FROM: Henry T. Bollmann, P. E., Chief, Bureau of Structures Design **HTB**

SUBJECT: STRUCTURES DIRECTIVES

FDOT - STRUCTURES DIRECTIVES
TOPIC INDEX

CONCRETE FINISHES

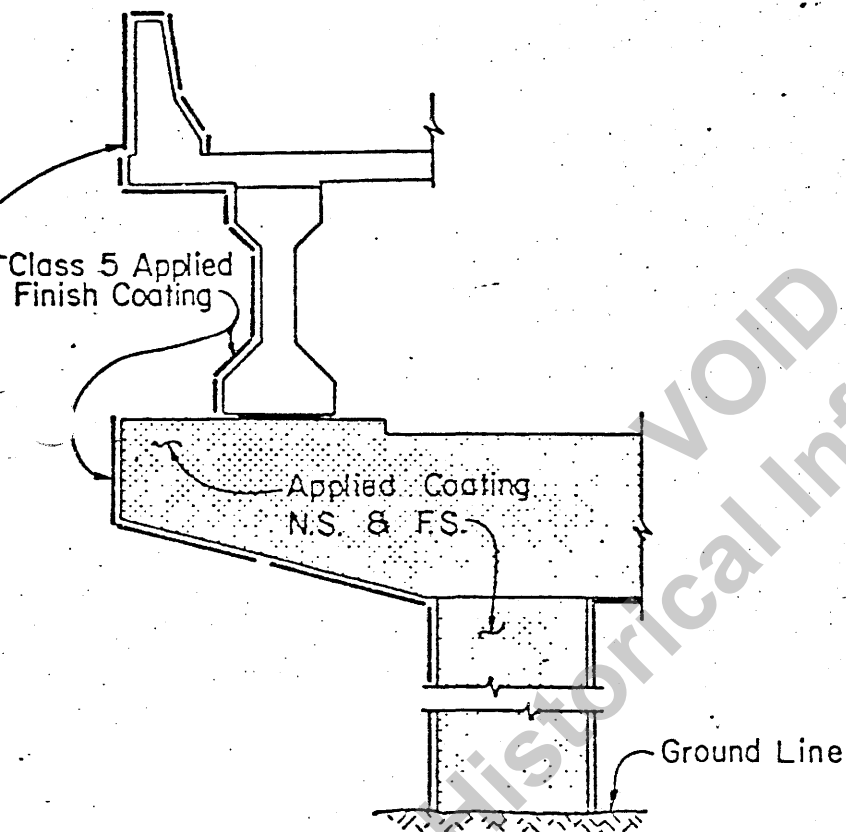
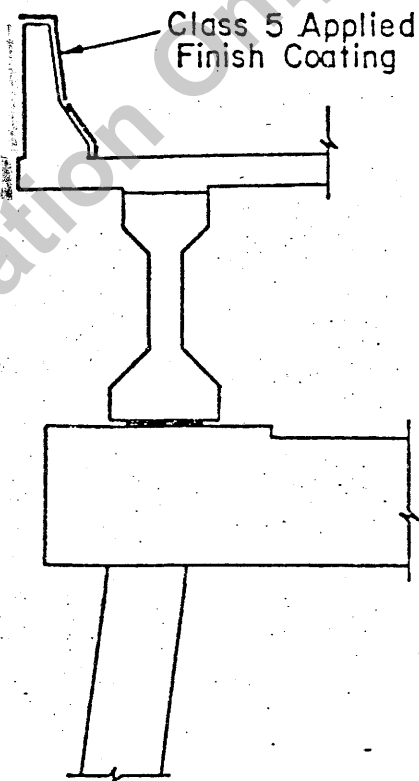
Attached is a drawing depicting the areas that are to receive a "Class 5 Applied Finish Coating". This is a concrete textured coating that the Department has decided to utilize as a final concrete finish on all structures. Please add the appropriate notes and sketches to all existing plans and plans prepared in the future that will implement the intent of the attached sketch.

NOTE 1 : All exposed surfaces as seen in Elevation, see detail below, and the following; exposed surfaces of end bent wingwalls and all exposed surfaces of piers above ground line except tops of caps shall receive a "Class 5 Applied Finish Coating",

NOTE 2 : All exposed top and inside surfaces of end bent wingwalls, the inside face and top of concrete barrier handrails, see detail below, shall receive a "Class 5 Applied Finish Coating"

INSTRUCTIONS FOR COMPUTING THE VOLUME OF CONCRETE IN BUILD-UPS OVER PRESTRESSED CONCRETE BEAMS

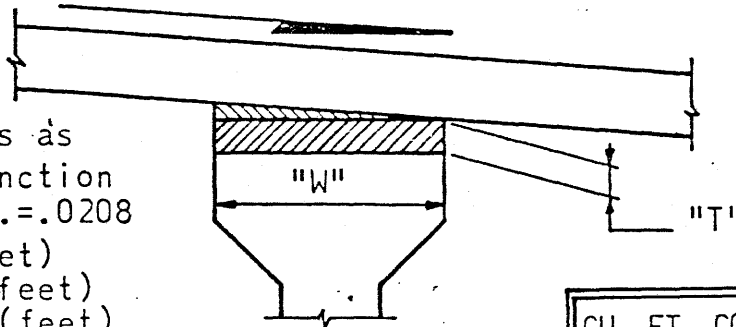
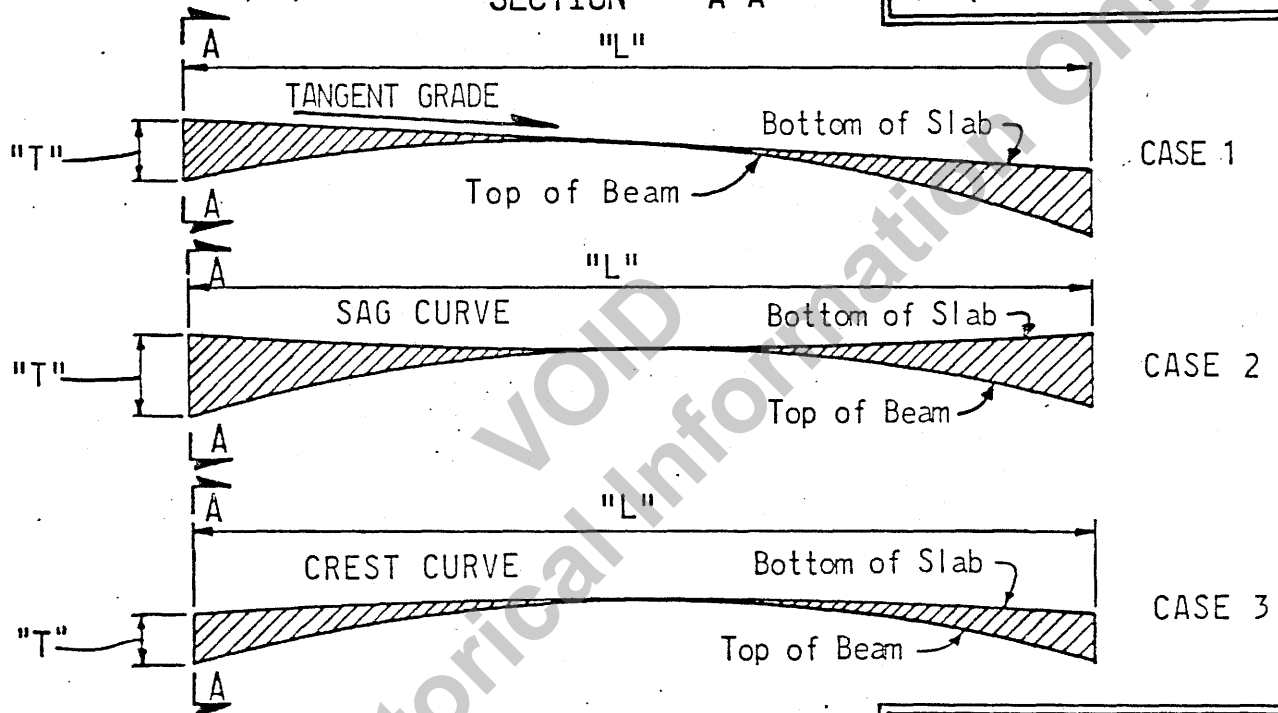
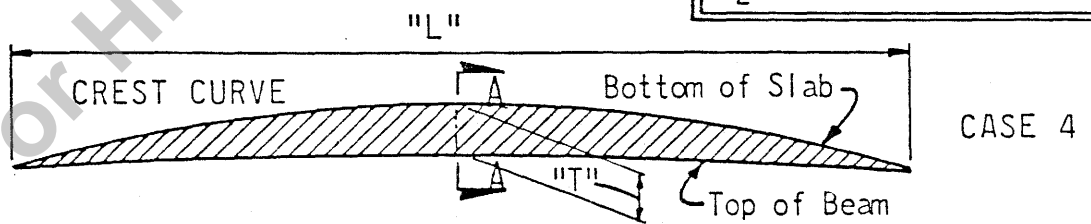
Enclosed is a revised sketch that supersedes our sketch of October 3, 1969, on the above subject.

MEDIAN BARRIER DETAIL

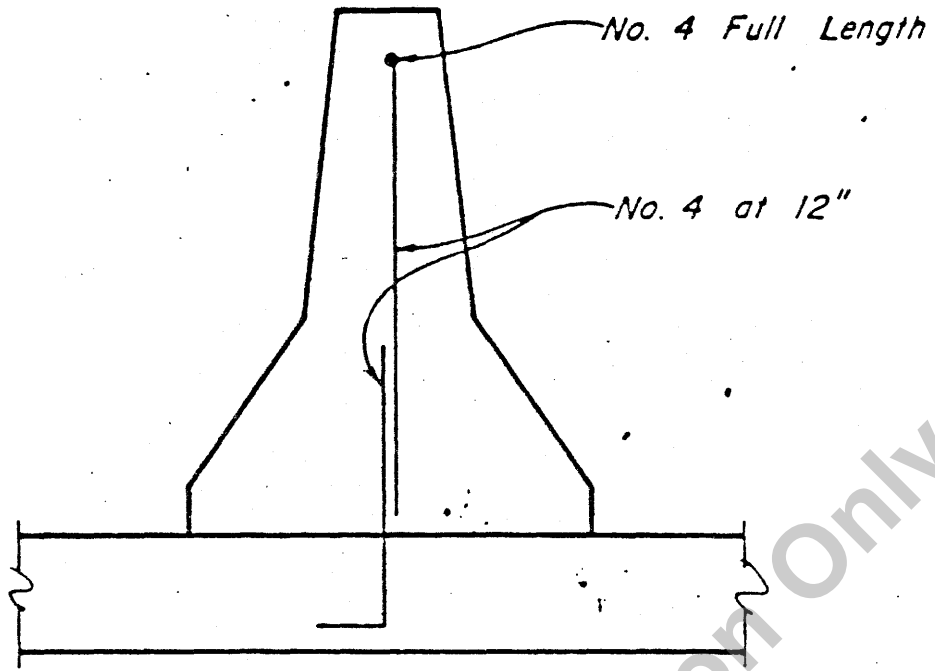
Attached is a sketch showing the reinforcing details that shall be utilized for all future median barriers on bridges without longitudinal deck joints.

SLOPE PAVEMENT

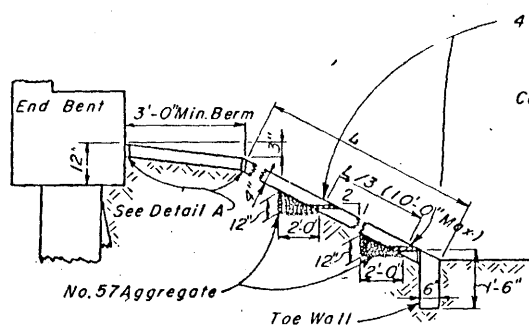
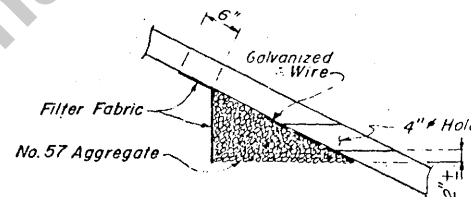
(1) Revised Slope Pavement Details

These details should provide for better drainage for the backfill behind the slope pavement.

Slope Pavement shall be tooled with a double $\frac{1}{4}$ " radius tool at 2 ft. \pm intervals along the slope at 4 ft. \pm across the slope. Construction joints will be permitted at joints as directed by the Engineer.

4" ϕ Holes at 8'-0" centers (staggered) shall be covered with galvanized wire with $\frac{1}{4}$ " openings and shall be backed with a continuous layer of No. 57 Aggregate, and filter fabric as shown. Cost of Holes, Wire, Filter fabric, and Aggregate to be included in the cost of Concrete Slope Pavement (4" thick).

PLAN SHOWING CONSTRUCTION JOINT LOCATIONS AT INTERIOR SUPPORTS

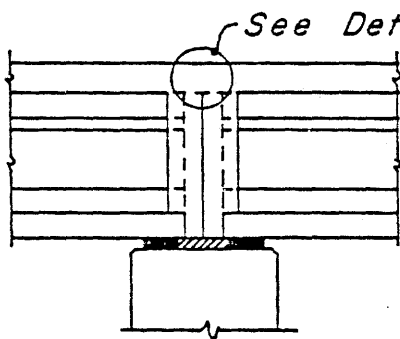
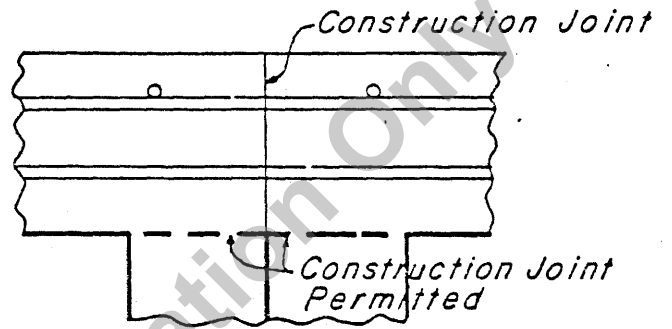
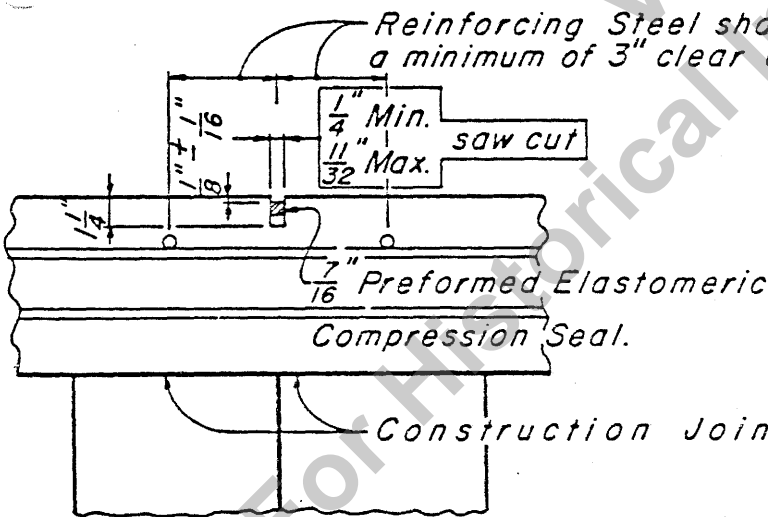
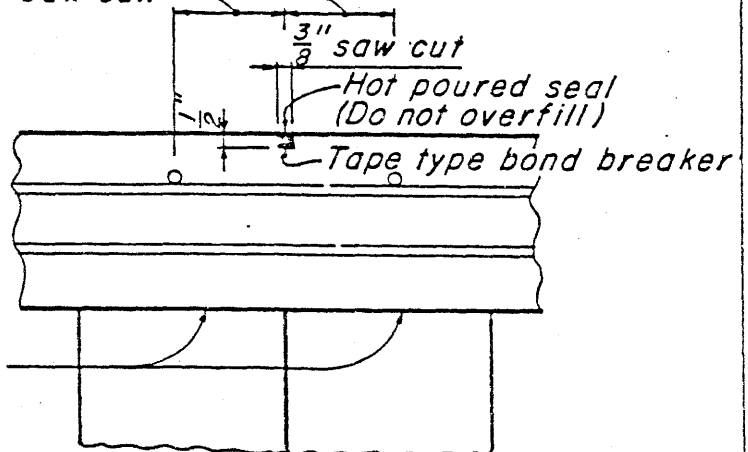
Attached is a revised sketch of the above subject. The revision consists of adding the following note to the sketch:

"On joints where saw cuts are made, the saw cut shall be made no later than the day following concrete placement."

NOTE: At the option of the Contractor either Alternate Detail A2 or Alternate Detail A3 may be used when slab pours are continuous over intermediate supports. The cost of constructing Alternate Joints at intermediate supports shall be at the Contractors expense. On Joints where saw cuts are made, the saw cut shall be made no later than the day following Concrete Placement.

Relocate Bolts in 1/2 End Posts for G.R.

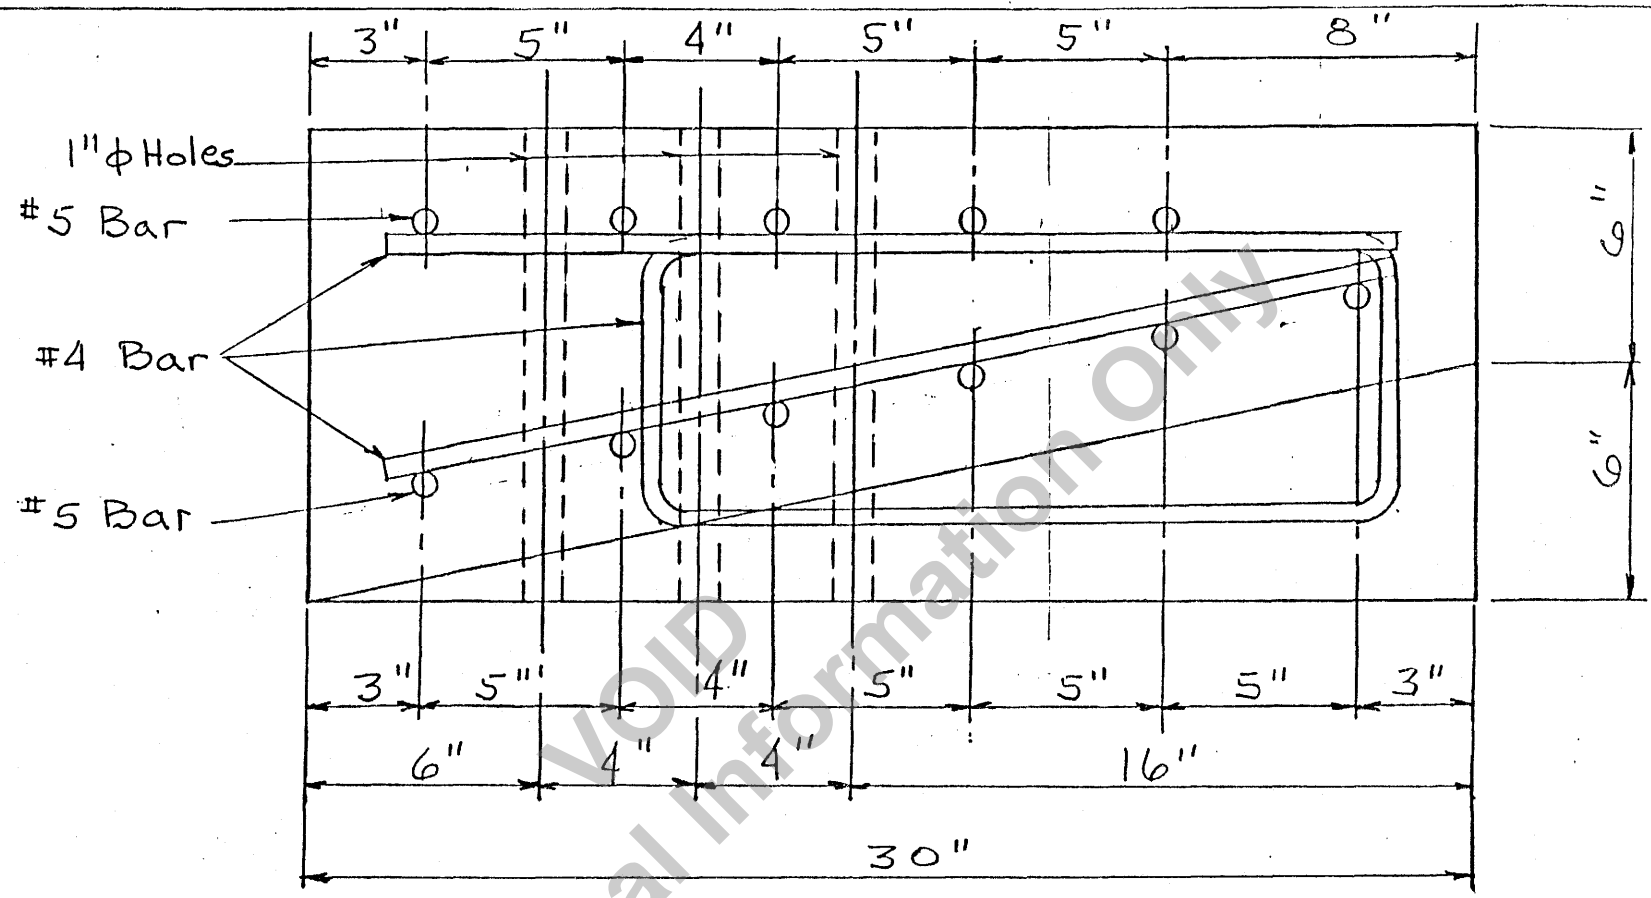
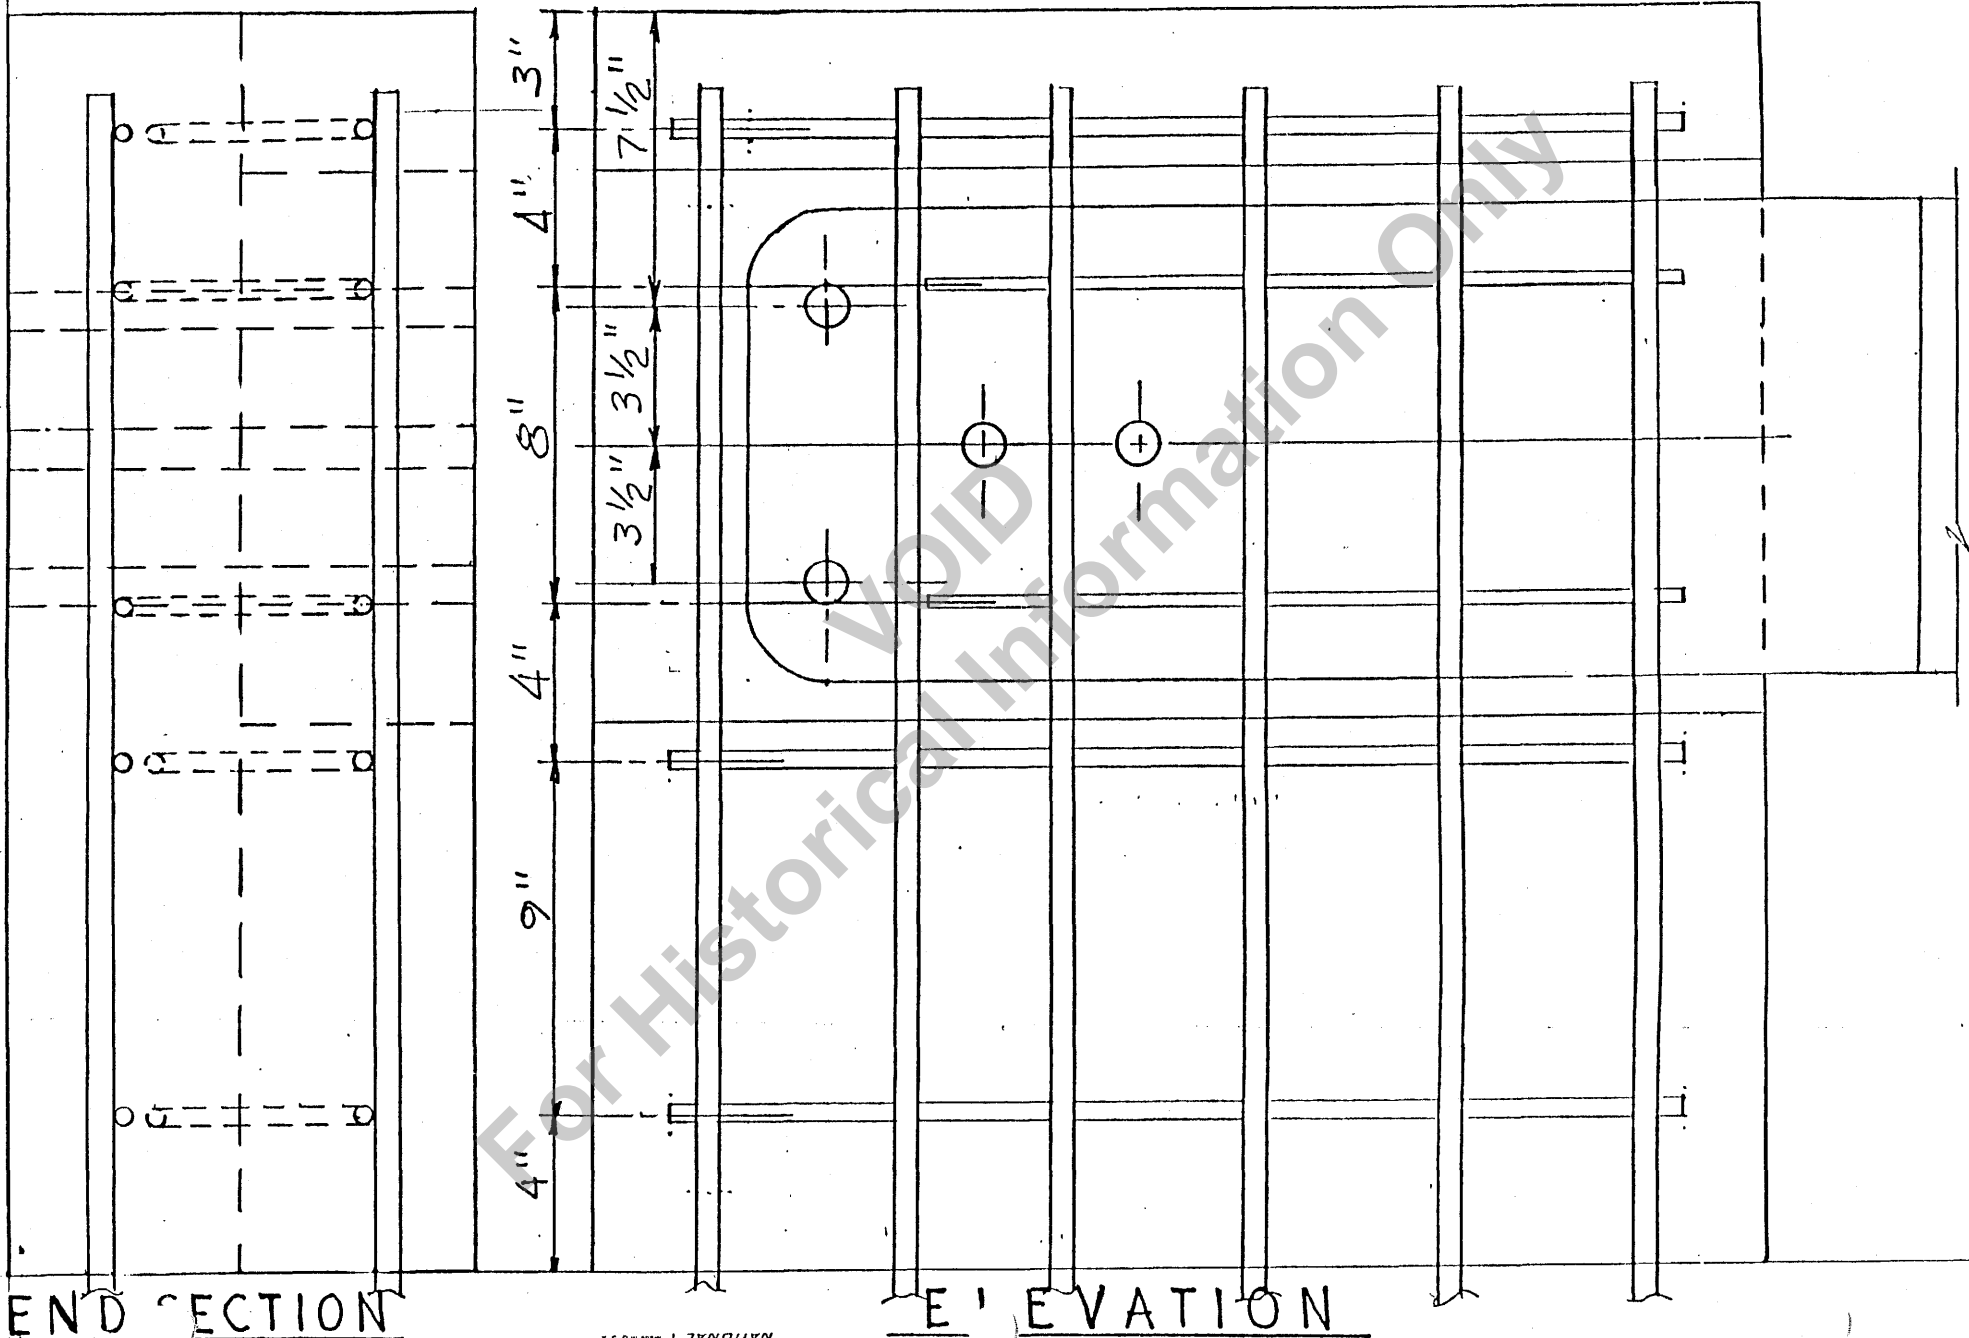
There have been incidents of conflict between the reinforcing steel and anchor bolts for both the wing post and the anchor post on the wingwalls of bridges.

In order to avoid conflict, it is suggested that the reinforcement be spaced and sized as shown in the attached sketches.

CONNECTION DETAILS FOR STIFFENERS

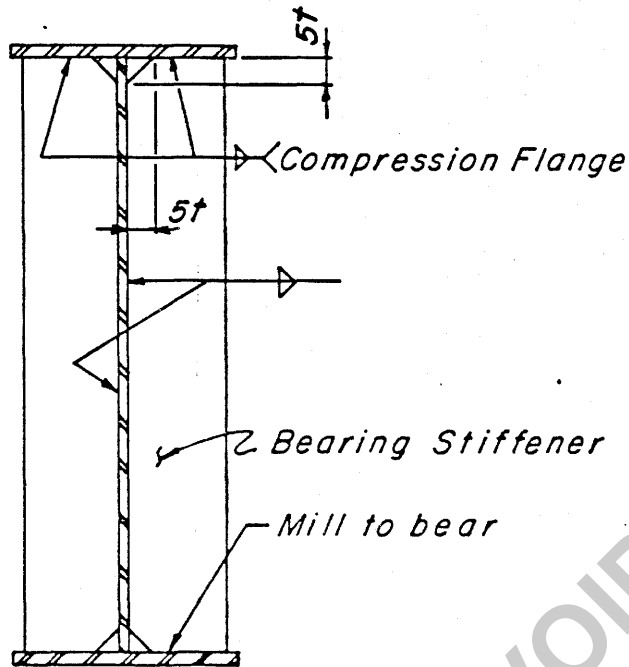
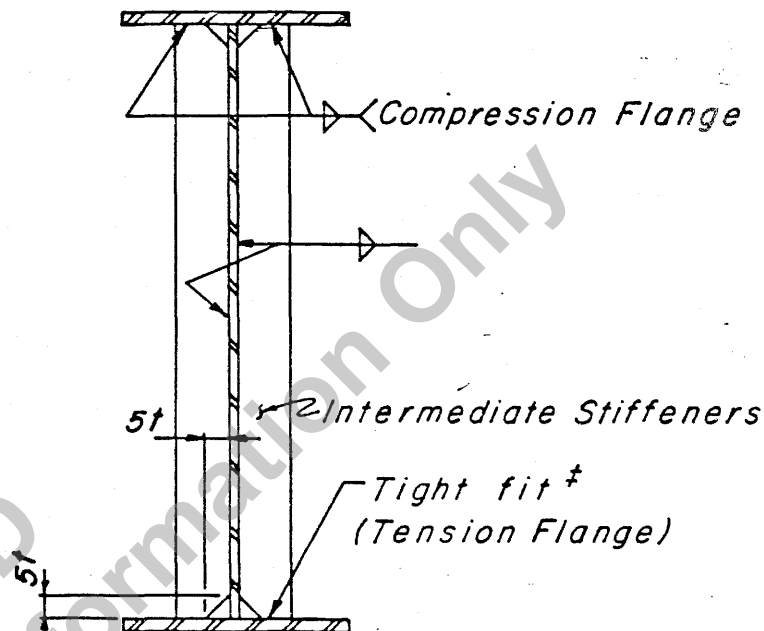
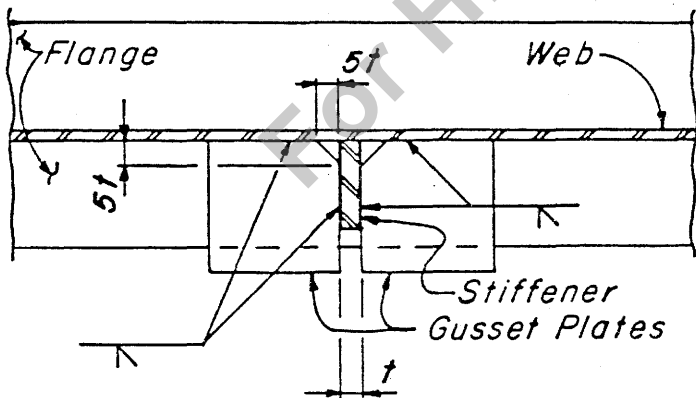
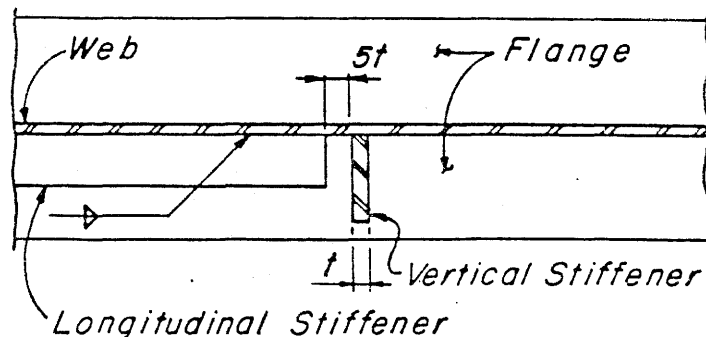
Attached is an up-to-date sketch for detailing gusset plates and stiffeners on all future structural steel projects. Please incorporate these details in all jobs presently being designed in your office.

NOTE: All Stiffener Plates at junction of flanges and web, and all Gusset Plates at junction of stiffeners and web shall have a triangle cut as shown below.

NOTE: Longitudinal Stiffeners shall stop clear of Vertical Stiffeners as shown above.
